Submission on Observations to the Draft Railway Order Application

May | 2023

Iarnród Éireann
Irish Rail

2.4.5 Anti-social behaviour in the underpass

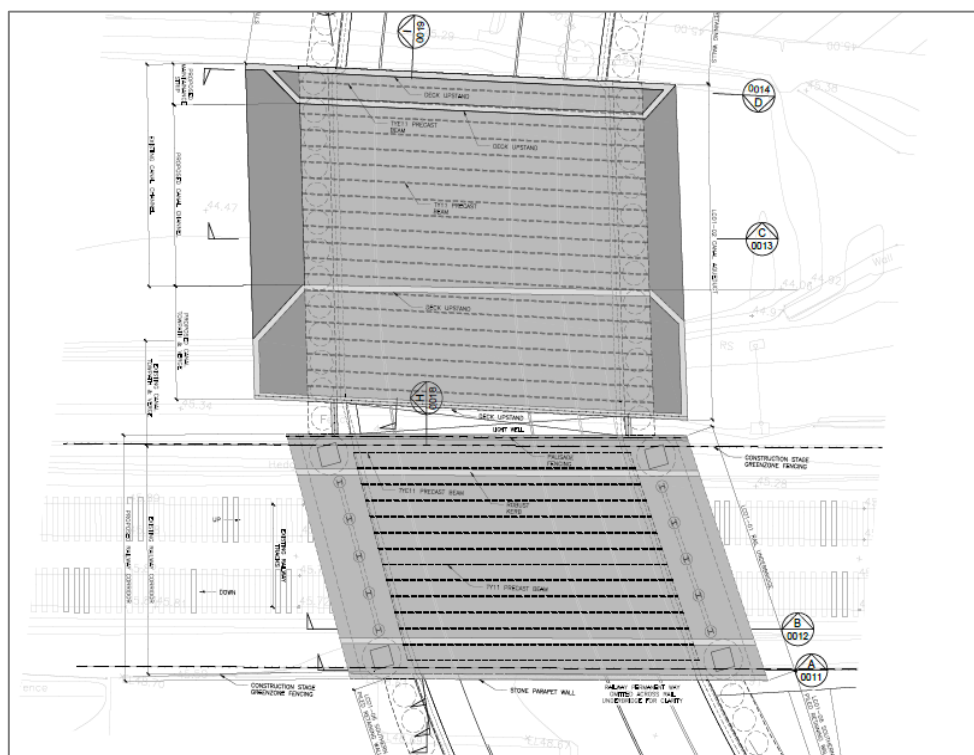
Concerns relating to the risk of anti social behaviour in the proposed underpass at Ashtown

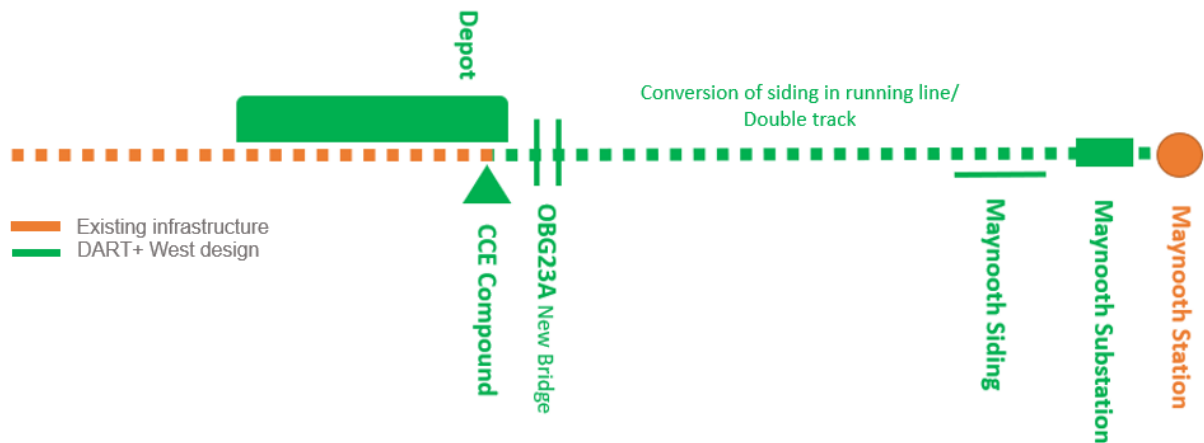
Respondents raised concerns over the closure of the level crossing at Blakestown with no alternative access being provided at the level crossing.

As outlined in Section 2.2.5 of this report, a number of options were developed and examined in respect of the treatment of each level crossing.

Due to the existing low levels of use by both vehicles and active modes the proposed development will permanently close the existing Blakestown level crossing. The project has determined that it does not require the provision of alternative infrastructure at this location. There is existing vehicular access available to properties that will be severed via the R449 and R418 Regional Roads. Access will be maintained to the future Collinstown employment lands via the R449 Regional Road which will provide direct access. Further access improvements are likely to be proposed as part of the Masterplan (once it is prepared).

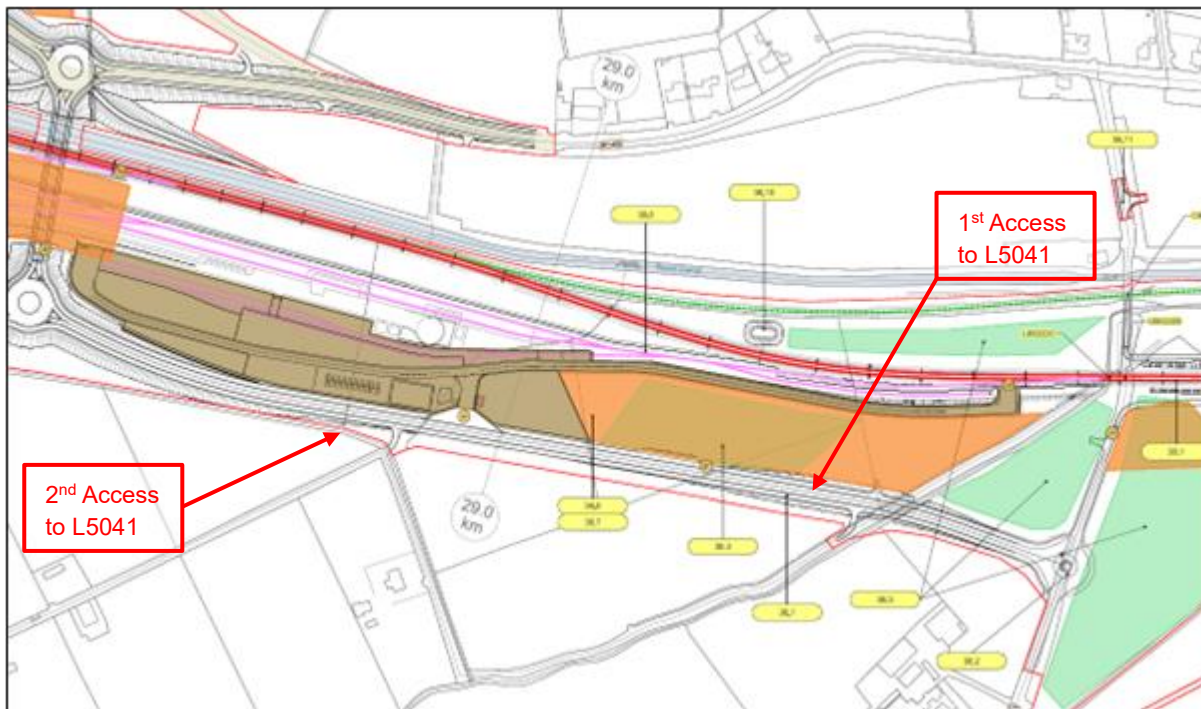
Submissions question that CIÉ are ignoring their rights of way that have been in existence for years and to alter private road layouts without consultation or agreement is unacceptable, while the introduction of an additional entrance onto a private lane from the new link L5041 will have on the security of their farms and properties.

No Right of Way is proposed to be acquired at this location while access to the L5041 is to be maintained, albeit through modifications to the local road network. The existing registered Right of Way does not currently extend to the L5041 based on information from the PRAI obtained in advance of the publication of the Railway Order or the post publication (29/03/2023) as shown in the figure below.
